UNITED STATES PATENT AND TRADEMARK OFFICE

APPLICATION NO.	FILING DATE	FIRST NAMED INVENTOR	ATTORNEY DOCKET NO.	CONFIRMATION NO.
10/524,812	02/18/2005	Horst Schulz	ZAHFRI P723US	1653
20210	7590	04/13/2006	EXAMINER	
DAVIS & BUJOLD, P.L.L.C. FOURTH FLOOR 500 N. COMMERCIAL STREET MANCHESTER, NH 03101-1151			MILLS, DANIEL J	
			ART UNIT	PAPER NUMBER
			3679

Office Action Summary	Application No. 10/524,812	Applicant(s) SCHULZ ET AL	
	Examiner Daniel J. Mills	Art Unit 3679

DETAILED ACTION

A. W. HALLBERG
LAVATORY FIXTURE
Filed July 8, 1925

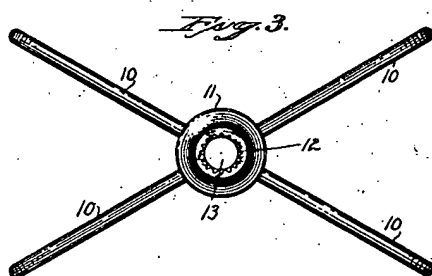
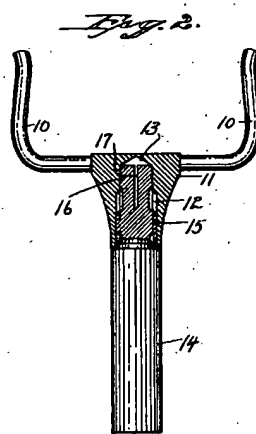
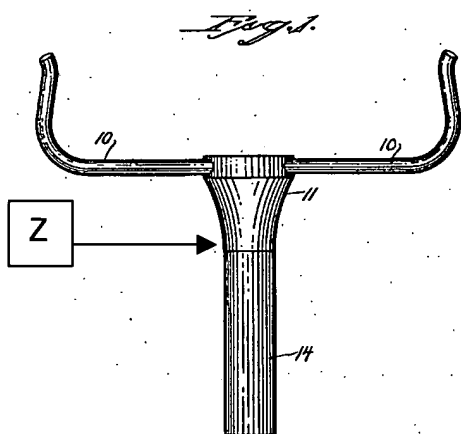
Regarding claim 13, Hallberg discloses a shaft-hub connection comprising a shaft (14) comprising; a first centering segment (16) located at a free end of the shaft having a first diameter, a second centering segment (C) axially spaced from the first centering segment; an intermediate toothed segment (15) located axially between the first and second centering segment, and the first centering segment and the intermediate toothed segment as well as the second centering segment have a same second diameter which is larger than the first diameter of the front centering segment; a hub (11) having a stepped aperture formed therein for receiving the shaft in an axial direction, the aperture consisting essentially of a first segment (13) having a first aperture diameter; a second segment having a second aperture diameter (12) which is larger than the first aperture diameter; and wherein the diameter of the first segment (internal diameter of the splines) is smaller than the diameter (root diameter of the splines) of the intermediate central toothed segment and when the shaft is inserted into the aperture to form the shaft-hub connection, the intermediate central toothed segment is forced into an overlapping axial engagement with the smaller diameter of the aperture. Hallberg fails to disclose that the intermediate central toothed segment is forced into an overlapping axial engagement with the smaller diameter of the aperture

Regarding claim 17, Hallberg in view of Mansel results in a shaft-hub connection wherein the second centering segment extends axially to a shaft collar (14) which abuts on a front face of the hub.
